RE: LQD 2016-2017 Annual Inspection Report, Uranium One, Willow Creek ISR Project, Permit No. 478

IN SITU MINE INSPECTION REPORT

Permit Number:	PT0478	Permittee:	URANIUM ONE USA INC
Inspection Date:	11/29/2017	Inspector(s):	Luke McMahan
Report Date:	1/9/2018	Participant(s):	Scott Schierman, Kevin Filbert
Last Inspection:	10/18/2016	Current Bond:	\$21,707,323
Inspection Reason(s):	Annual	Field Conditions:	Clear, windy, dry, all areas accessible, ~55° F
		Approval Date:	4/18/1978

Photo #1: Irigaray Site Permit Sign.

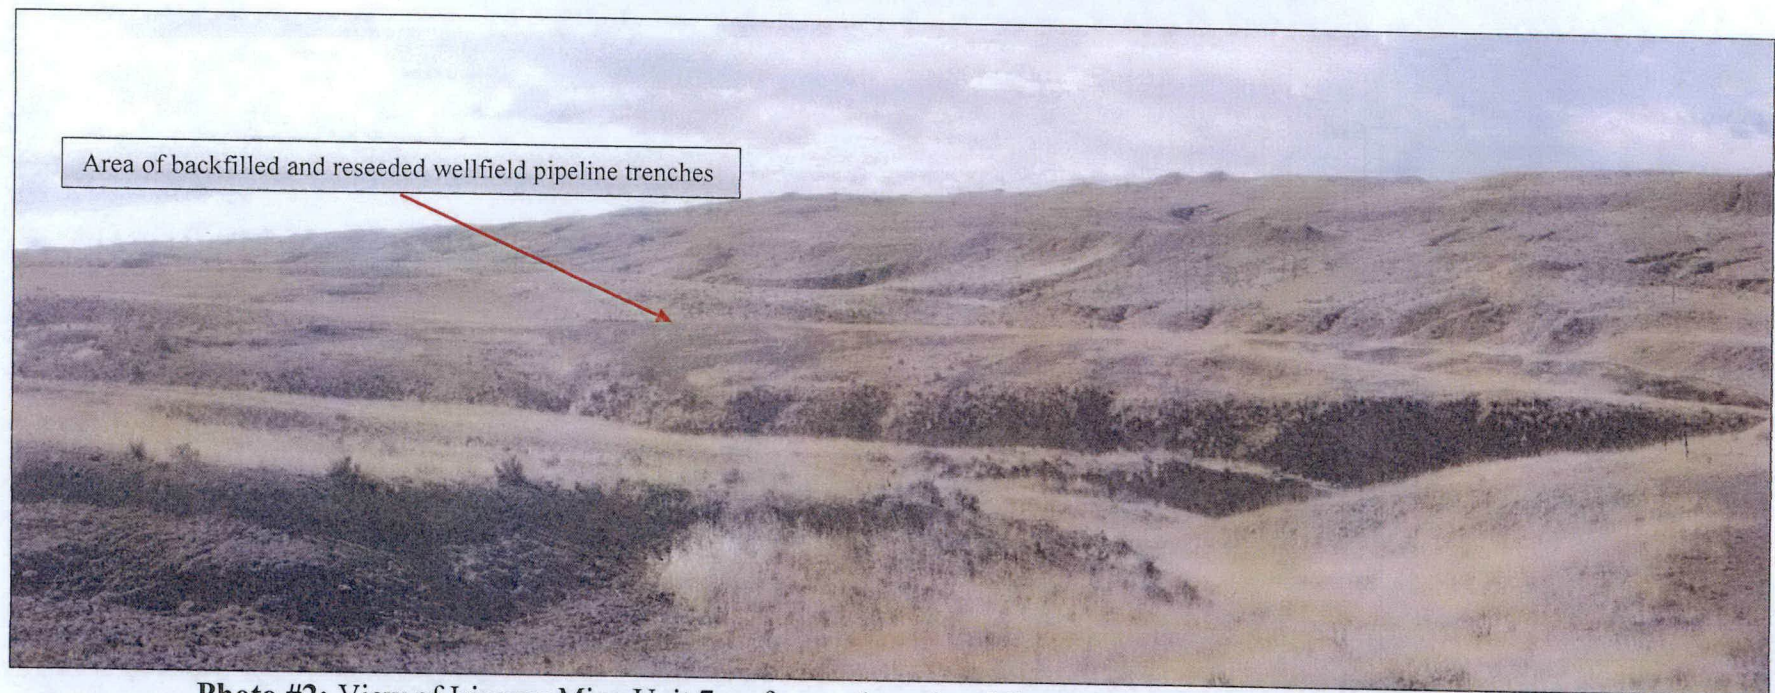
• Signs	Yes
<p>The permit signs for the Irigaray site and the Christensen Ranch site were found to be up to date and posted with the appropriate information (Photos #1 and #5).</p>

Photo #6: Overview of CR Facility; satellite plant, office building, evaporation ponds and maintenance area, looking NE from DDW site.

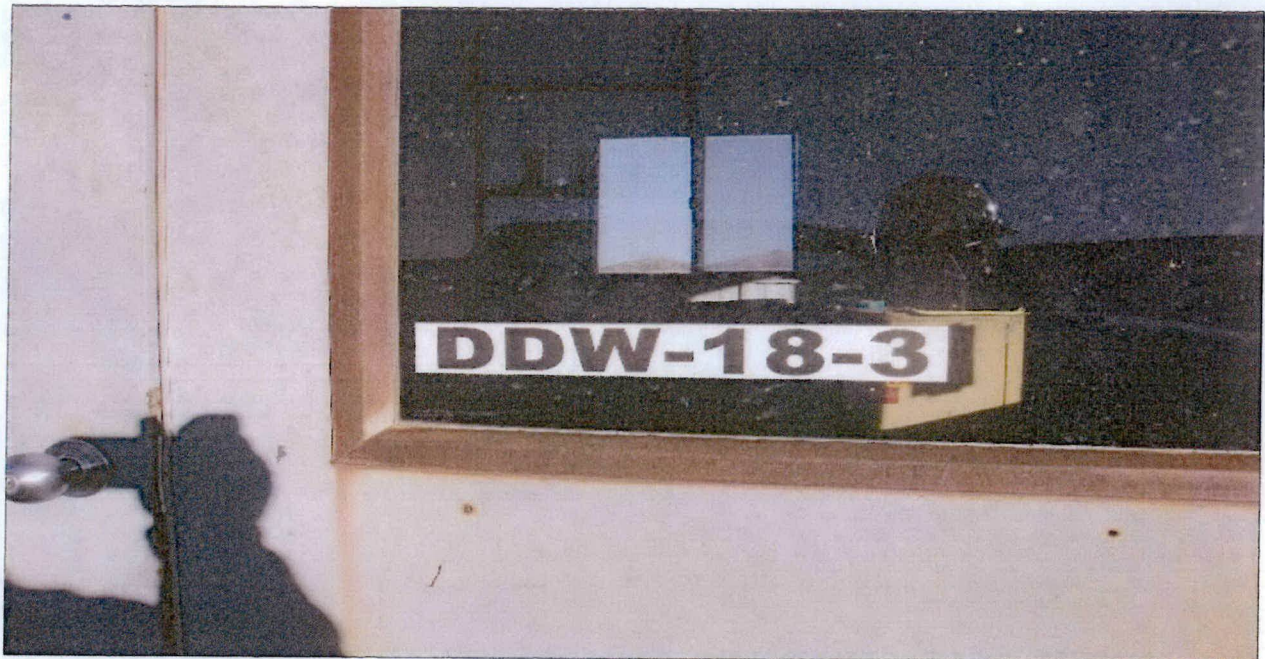
Inspection Topic	In Compliance
• Ponds	Yes
<p>The evaporation ponds (active and inactive) located at the Irigaray and Christensen sites were viewed in passing. The Irigaray facility has seven (7) ponds, three of which have had their liners removed and are no longer in use. The remaining four, IR-B, IR-D, IR-RA, and IR-RB were in use at the time of the inspection and no issues were identified with the Irigaray ponds. The Christensen facility has five (5) ponds, all of which were in use at the time of the inspection (Photo #6). No issues with the Christensen facility ponds were identified during the inspection.</p>

Photo #8: View of Christensen Ranch Facility DDW-18-3.

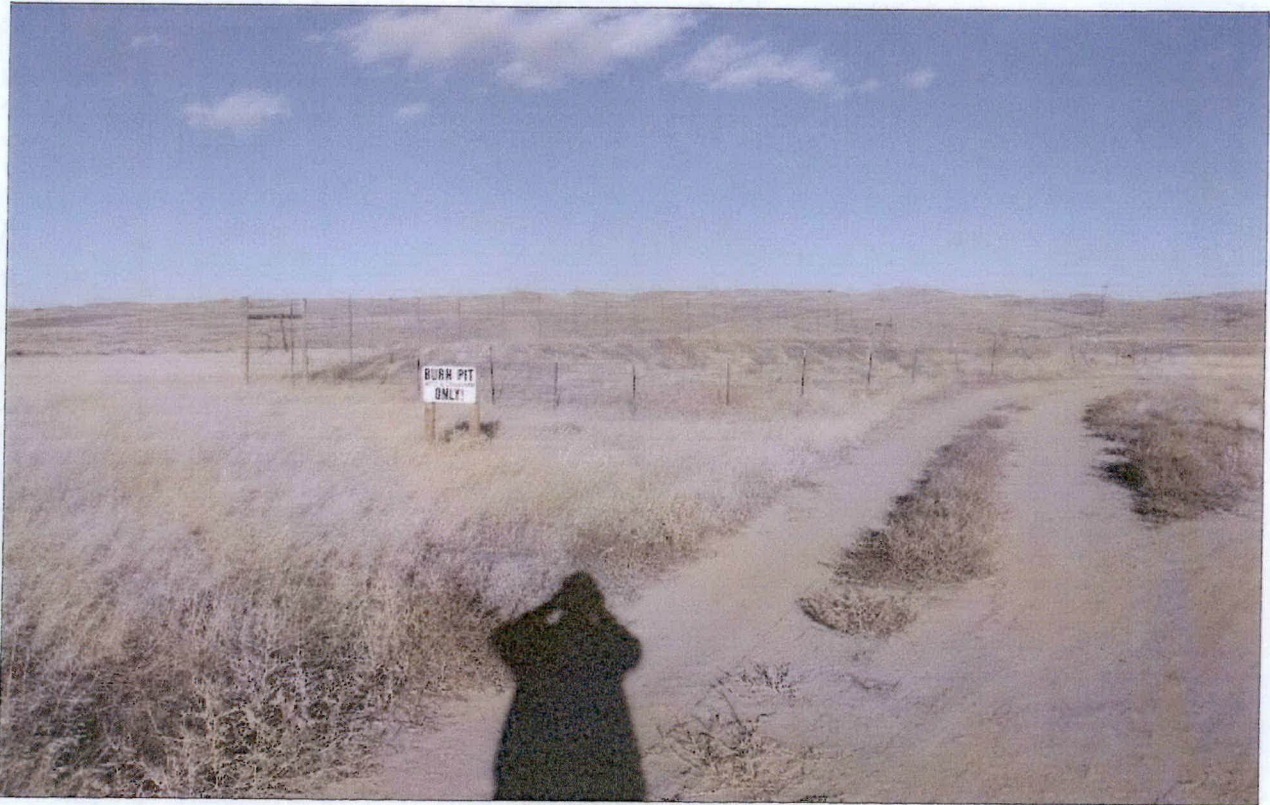
• Deep Disposal Wells	Yes
The Willow Creek Mine has two (2) Class I Deep Disposal Wells, Christensen Ranch DW-1 and Christensen Ranch 18-3. Both wells are located at the Christensen Ranch Facilities area. The wells are permitted for injection of industrial wastes under the WDEQ Water Quality Division (WQD) Permit UIC 10-219. Construction, operation, mechanical integrity testing standards and the cost of reclamation are under the purview of the WQD UIC permit. However, the bond amount posted by Uranium One for reclamation of the wells is held by LQD in accordance with the LQD permit to mine for Willow Creek. Both wells were operational at the time of the inspection. No evidence of significant leakage or spills around the wellheads or around the well facilities was observed (Photos #7 & #8).

Photo #11: View of Christensen Ranch Topsoil Stockpile #28, typical of CR stockpiles viewed.

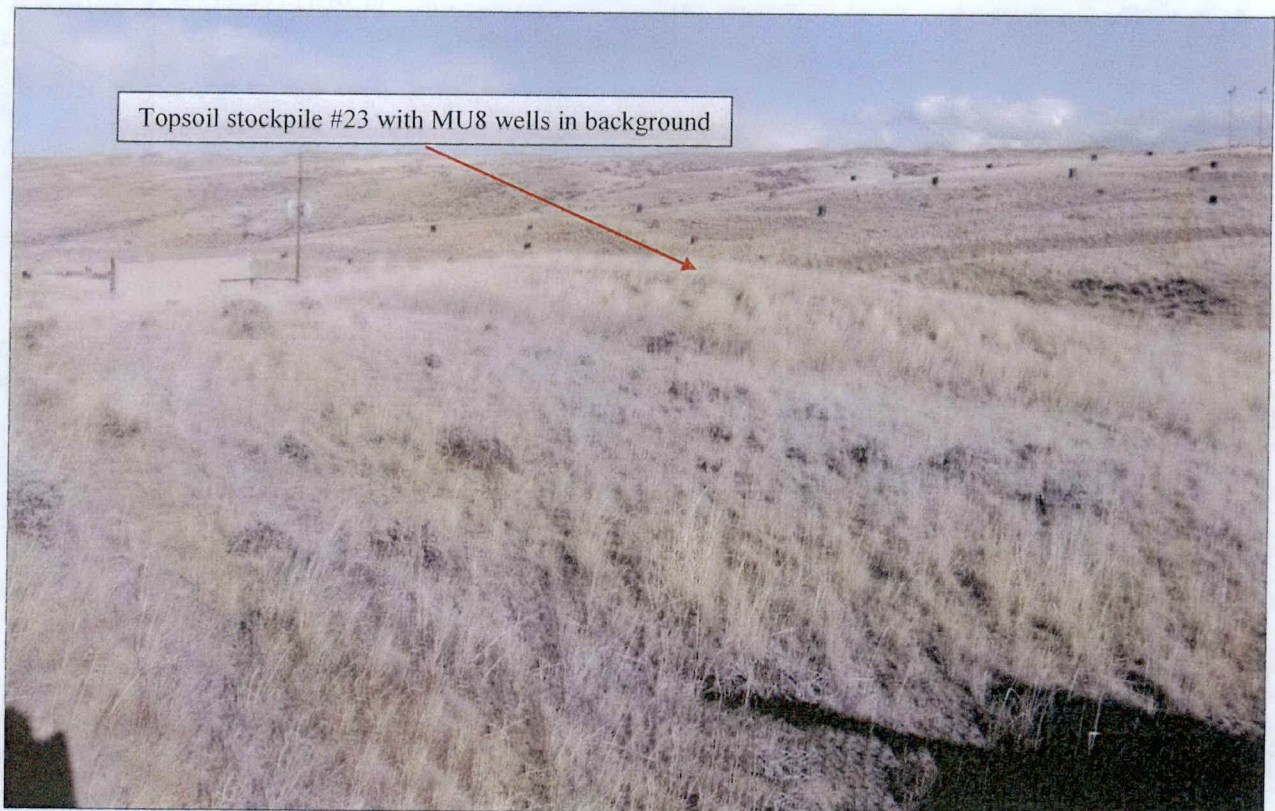
• Topsoil Stockpiles	Yes
<p>Based on the Annual Report and the Annual Inspection, a total of 49 topsoil stockpiles (Photos #4 & #11) and two (2) subsoil stockpiles (Photo #21) are present at Willow Creek Mine. All of these stockpiles were viewed during the annual inspection and were found to be in stable condition with no erosional issues. Two (2) of the topsoil stockpiles, #23 & #30 were found to be missing topsoil identification signs. Following the inspection, Uranium One posted topsoil signs at stockpiles #23 and #30 and emailed photographs of the identification signs posted at stockpiles #23 and #30 to the inspector on November 30, 2017 (Photos #12, #13, #14, #15). Topsoil stockpiles #35 & #36, not listed in the Annual Report topsoil stockpile table but shown on the Annual Report map for the Christensen area, could not be located during the inspection. Although #35 & #36 could not be located, it was noted during the inspection that these stockpiles were quite small and relatively difficult to see from a distance. Following the inspection, Uranium One found and verified the mapped locations for stockpiles #35 & #36, and emailed photographs to the inspector on November 30, 2017 (Photos #16, #17).</p> <p>Of the Forty-nine topsoil stockpiles viewed during the inspection, three (3) of the topsoil stockpiles were not listed in the Annual Report stockpile table or on the Annual Report maps. The three unnamed topsoil stockpiles were found located next to the maintenance area burn pit (43.802264, -106.031164), located next to the Mine Unit 3 access road (43.807297, -106.034825), and located next to the access road between Mine Unit 4 and Mine Unit 5 (43.785218, -106.028453). These stockpiles were found to be stable and posted with a topsoil identification sign (Photos #18, #19, #20). As requested in LQD's annual report review memorandum, these stockpiles will need to be added to the applicable annual report table and map.</p>

Photo #13: View of CR Topsoil Stockpile #23 with topsoil identification sign posted.

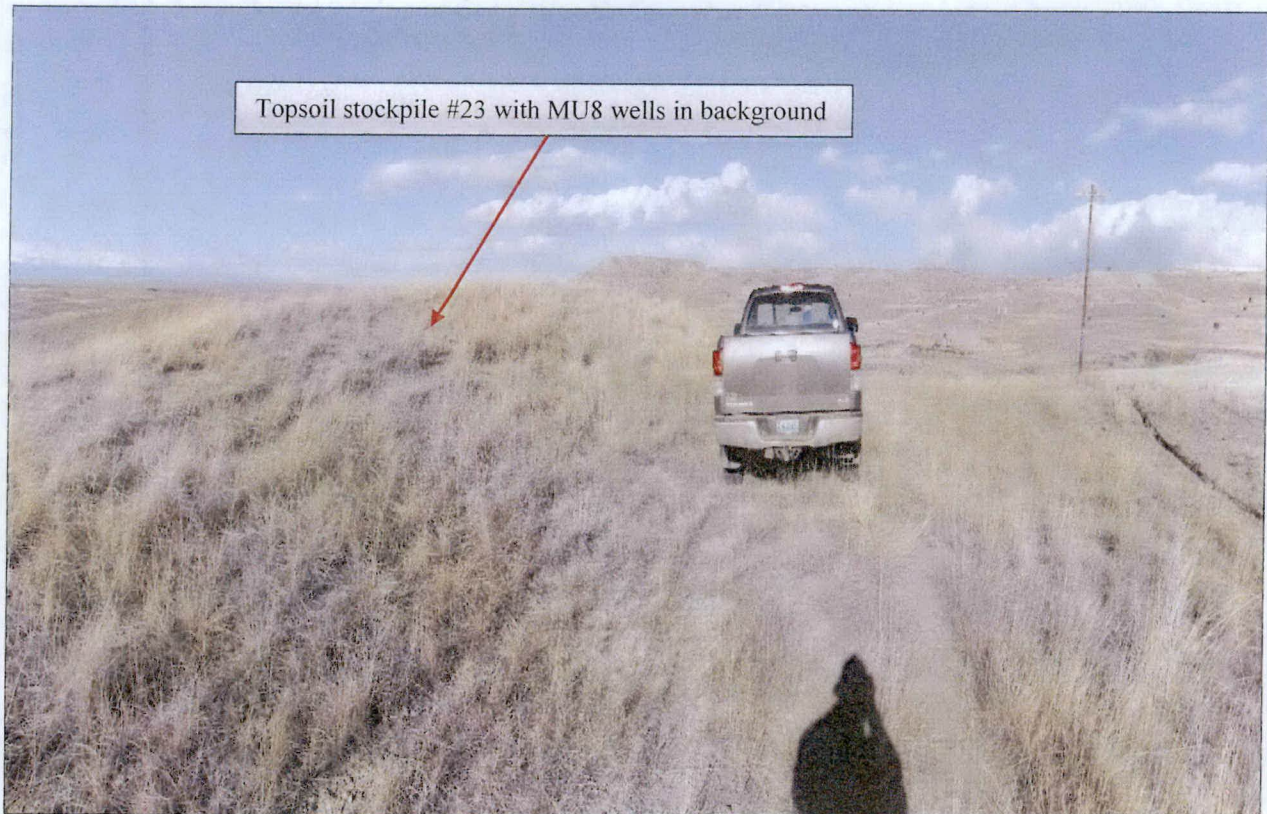
Photo #12: View of CR Topsoil Stockpile #23, no topsoil identification sign present.
